**WATERTOWN CITY COUNCIL
WORK SESSION AGENDA
CITY HALL
23 SECOND STREET NORTHEAST
WATERTOWN, SOUTH DAKOTA**

TO: Shane Waterman, City Engineer - Watertown
FROM: Rocky J. Keehn, PE, CFM
DATE: April 8, 2016
RE: Review of Stony Point 3rd Addition H&H
SEH No. 14.00

RE: Stony Point Third Addition Plan Review - March 2016 Update

Figure 1. 100-year inflow hydrograph (blue Hyd No. 1) and BMP outflow hydrograph (red Hyd No. 2) for Area A.

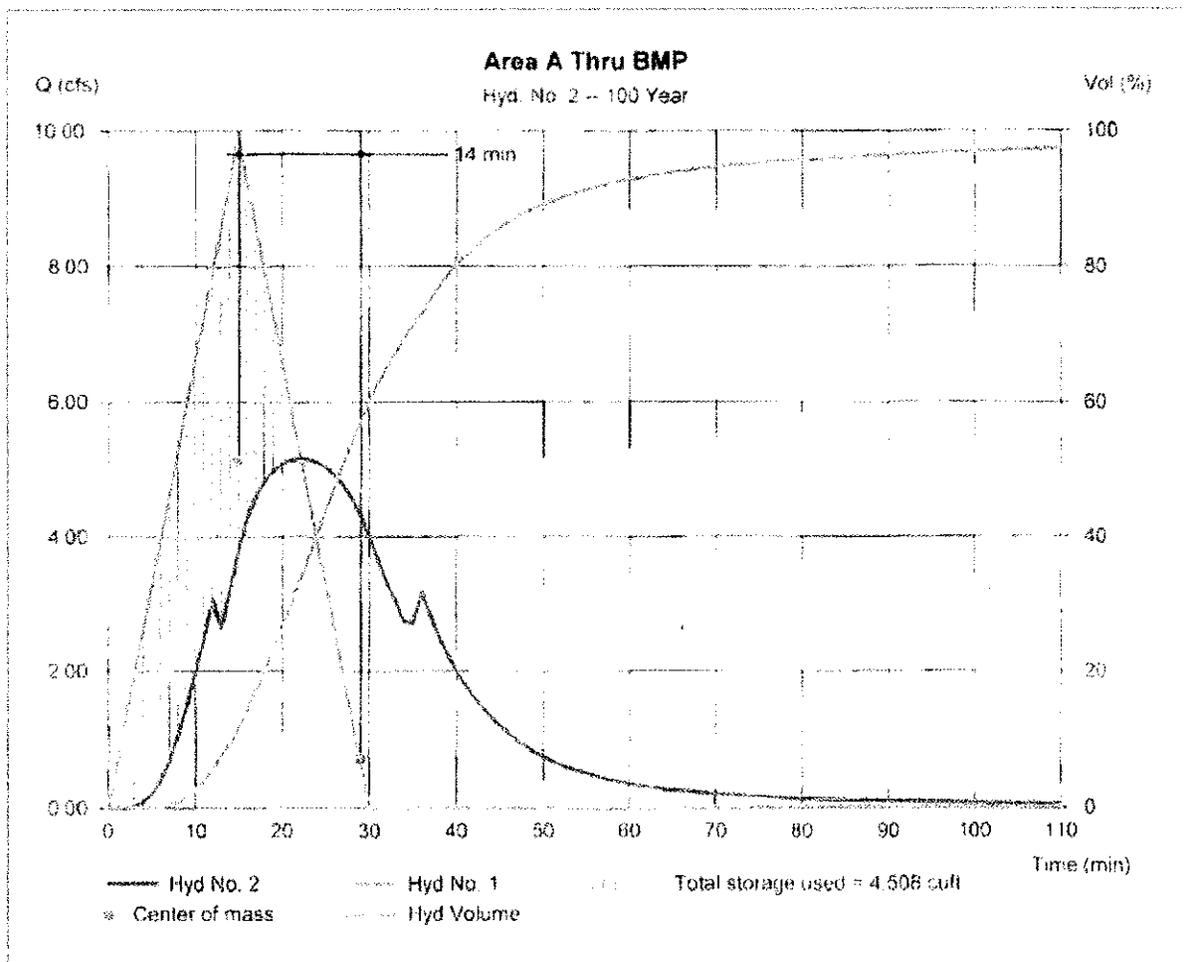
Figure 1 shows that the outflow hydrograph has jumps in both the rising and falling limbs of the outflow hydrograph. Similar outflow hydrograph characteristics appear in in the hydrograph reports for the Area C BMP. It is our experience and opinion that the characteristics of these outflow hydrographs may

indicate errors in routing calculations. As a BMP fills with water from a steady inflow hydrograph and the ponded depth increases, the outflow hydrograph should only ever increase up to the peak flow rate; it should not decrease prior to the peak.

It can also be seen in Figure 1 that the inflow hydrograph has a peak of 9.9 cfs, time to peak of 14 minutes, and total duration of 30 minutes. At 9.9 cfs, the peak flow of this hydrograph matches the post-development 100-year peak flow calculated for Area A (shown in Table 3). However, this hydrograph does not represent runoff produced by the SCS Type II 24-hour design storm. This hydrograph has a total volume of 0.08 acre-feet, while Table 3 shows that the 100-year runoff volume for Area A should be around 0.66 acre-feet. Figure 2 shows a hydrograph produced with HydroCAD using the characteristics of Area A and the SCS Type II 24-hour storm at the 100-year rainfall total of 5.76 inches for Watertown, and compares it to the hydrograph used in the plans. The SCS Type II produces a hydrograph containing approximately 0.66 acre-feet, matching the total volume estimated in Table 3.

Figure 2. Comparison of the hydrograph used in the plans (blue) and the hydrograph produced by the SCS Type II 24-hour design storm for the 100-year event over Area A.

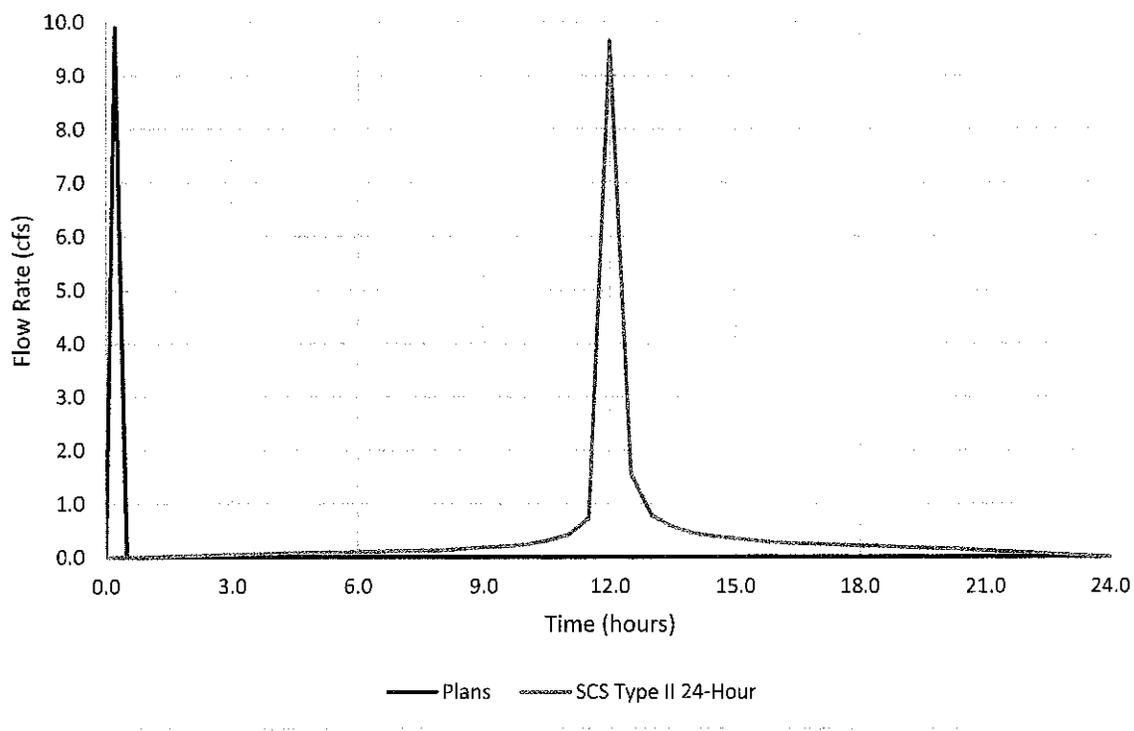
The timing characteristics of the hydrograph used in the plans for Area A are the same for all hydrographs used in the plans to size the proposed BMPs; each used the appropriate peak flow rate, but a time to peak of about 15 minutes and a total duration of 30 minutes. These characteristics result in significant underestimation of the storage volume required for each BMP. Table 5 compares the post-development runoff volumes estimated using the Rational Method as specified in the Manual with the hydrograph volumes used for BMP sizing and outlet configuration.
